N-4080-026 Suppl A Rev 0: LOCA Containment P/T

Southern California Edison Company NON-TECHNICAL DESIGN CHANGE NOTICE (DCN) / CALCULATION CHANGE NOTICE (CCN) COVER SHEET	DCN/CCN NO. <u>CCNNT 3</u>	DOCUMENT REVISION		
	DOCUMENT NO. <u>N-4080-026, SUPPLEMENT A</u>	SHEET NO. <u>07/16/97</u>	REV. <u>0</u>	UNIT(S) <u>2 & 3</u>
	DOCUMENT TITLE <u>CONTAINMENT P-T ANALYSIS FOR DESIGN BASIS LOCA</u>			
	ORIGINATOR <u>Paul Barbour</u>	PAX <u>88351</u>	DATE <u>07/16/97</u>

Subject CONTAINMENT/T ANALYSIS for DESIGN BASIS LOCA Sheet No. A-11

FIGURE 2-1
LOCA WITH LOP - CONTAINMENT PRESSURE

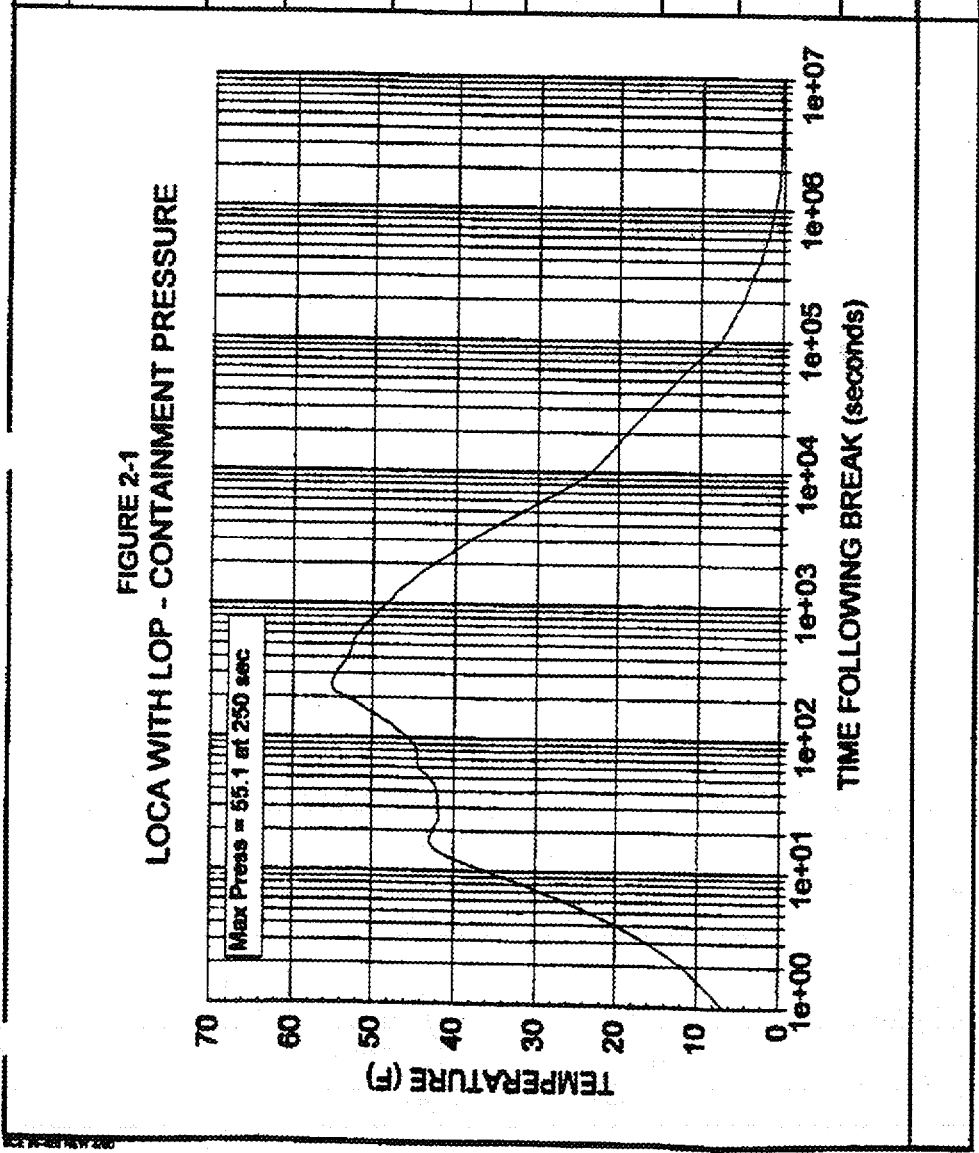
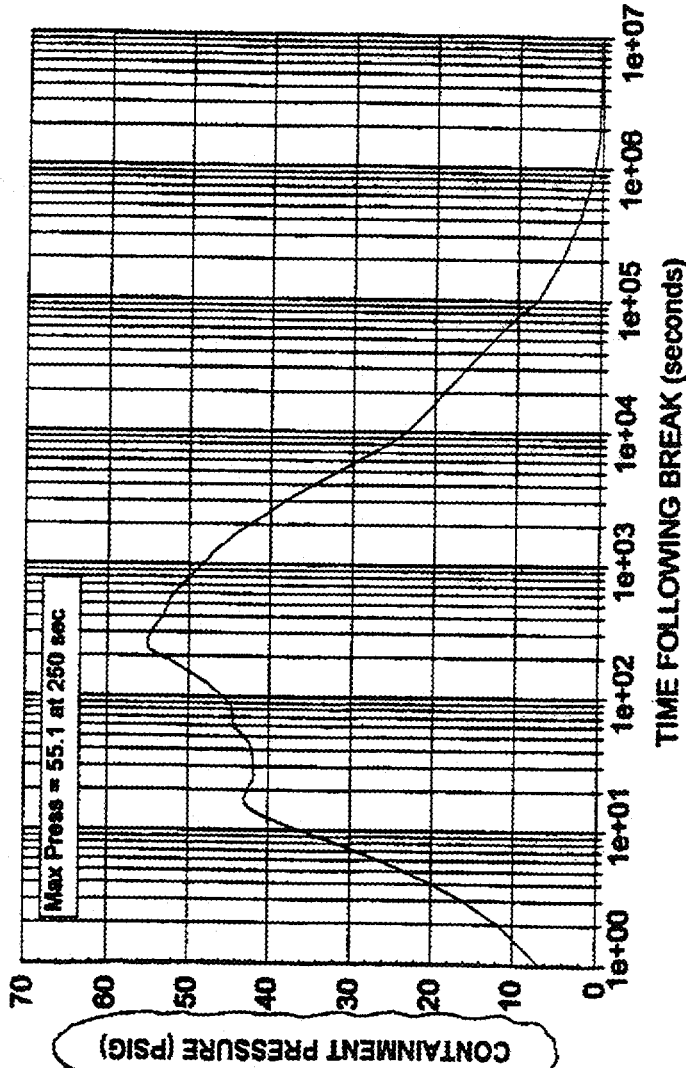
Change the vertical axis label for Figure 2-1 from "TEMPERATURE (F)" to "CONTAINMENT PRESSURE (PSIG)" as shown on sheets 2 and 3 of this CCN.
